1988 - 1989 Corvette: Hood Rubs Air Conditioning Hose

Source: Chevrolet Dealer Service Bulletin

Bulletin No: 89-183-1B

Date: June 1989

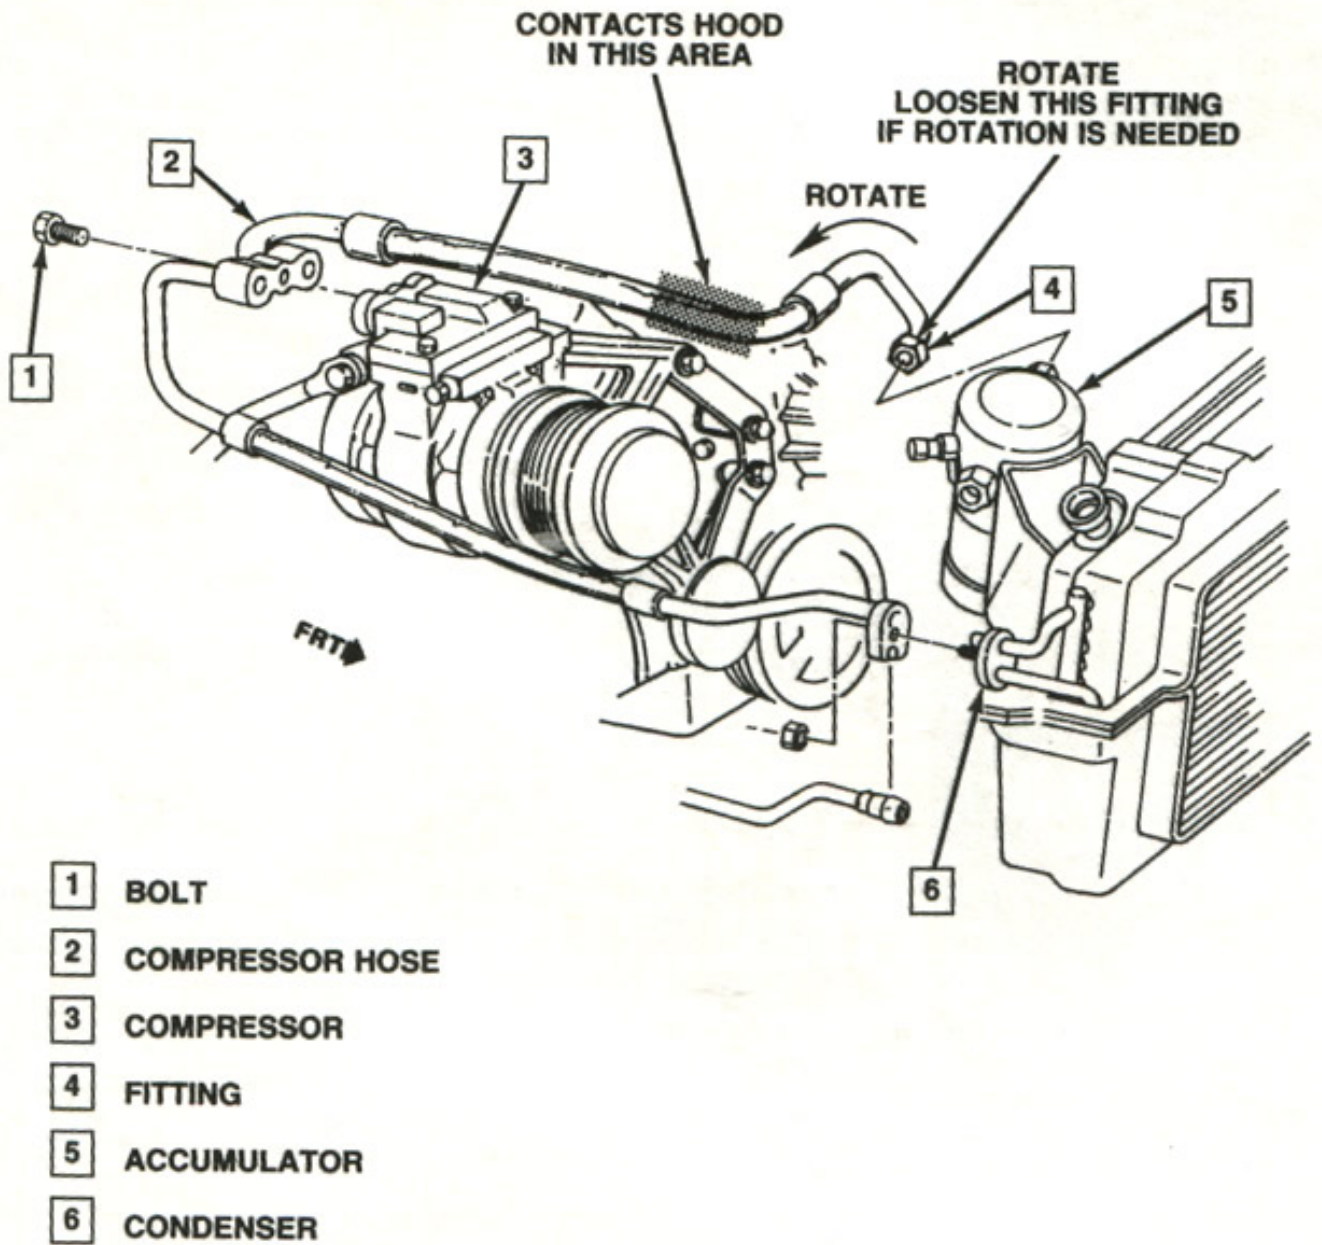
Some of the above vehicles, built prior to the breakpoint shown below, may exhibit a rub condition of the A/C hose to the underside of the hood. use the following procedure to check and address this condition. (Figure 1 shows hose disassembled for clarification only).

1. Check the area of A/C hose, as indicated in Figure 1, to see if it is contacting the hood. If there is no evidence of hose contact to hood, no further action is needed.
2. If the hose is contacting the hood but has not rubbed through the outer coating of hose, loosen the nut (item #4) on the accumulator (Item #5) and rotate the hose, in the direction indicated in Figure 1, to obtain clearance to the hood.
3. if the hose is rubbed through the outer coating, replace the hose assembly with one of the following service part numbers.
